Item Name: Basket Hoop

DESIGN #	DRAWN BY CP	DART AEROSPACE LTD HAWKESBURY, ONTARIO, CANADA	
CHECKED #	APPROVED #	DRAWING NO. D3166	REV. A SHEET 1 OF 1
DATE 02.07.10		TITLE BASKET HOOP	SCALE NTS
A	02.07.10	NEW ISSUE	
A1	04.04.08	38+/-1 WAS 36.0

DRAWING NO. D3166	TITLE BASKET HOOP	REV.A1	DART AEROSPACE LTD ENGINEERING ORDER		D.E.O. NO. D3166-A-2	SHEET NO. 1 OF 1	SCALE NTS
DRAWN AJS	CHECKED <i>[Signature]</i>	MFG. APPR. <i>[Signature]</i>	APPROVED <i>[Signature]</i>		DE APPR. <i>[Signature]</i>		
DATE 08.12.11	DATE 08.12.15	DATE 08/12/15	DATE 08/12/16		DATE 08.12.16

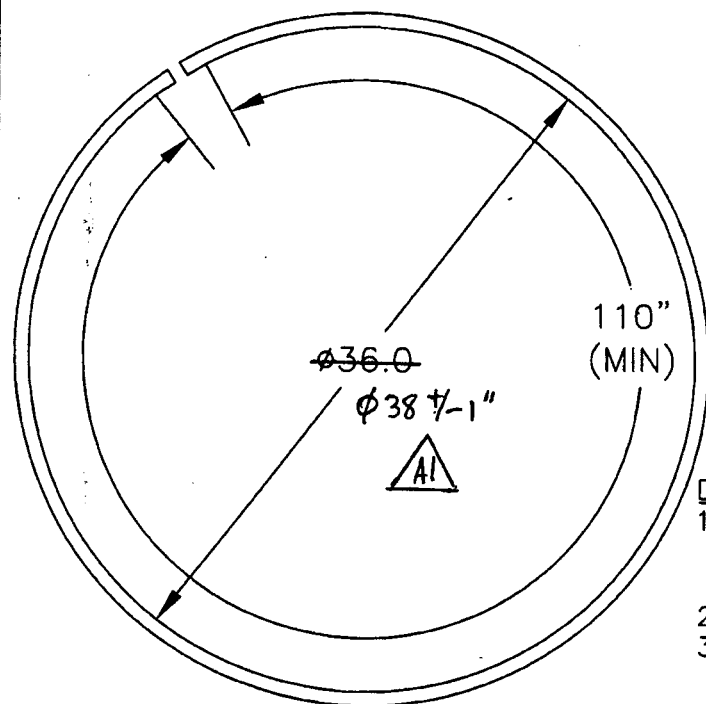
1) MODIFY MATERIAL NOTE FOR D3166-1 AS SHOWN:

WAS:

- 1) MATERIAL: AISI 304/316 SS SQUARE TUBING,
0.75" x 0.75" x 0.063 WALL, 60.00" LONG
(REF DART SPEC. M304TS0.750W.063)

2) MODIFY MATERIAL NOTE FOR D3166-3 AS SHOWN:

WAS:

- 1) MATERIAL: AISI 304/316 SS SQUARE TUBING,
0.75" x 0.75" x 0.063 WALL, 120.00" LONG
(REF DART SPEC. M304TS0.750W.063)

REASON: SEE PAR 08-005

IS:

- 1) MATERIAL: AISI 304/316 SS, 3/4 X 3/4 X 0.065 WALL SQUARE TUBING,
60.00" LONG
REF. DART SPEC M304TS0.750W.065

IS:

- 1) MATERIAL: AISI 304/316 SS, 3/4 X 3/4 X 0.065 WALL SQUARE TUBING,
120.00" LONG
REF. DART SPEC M304TS0.750W.065
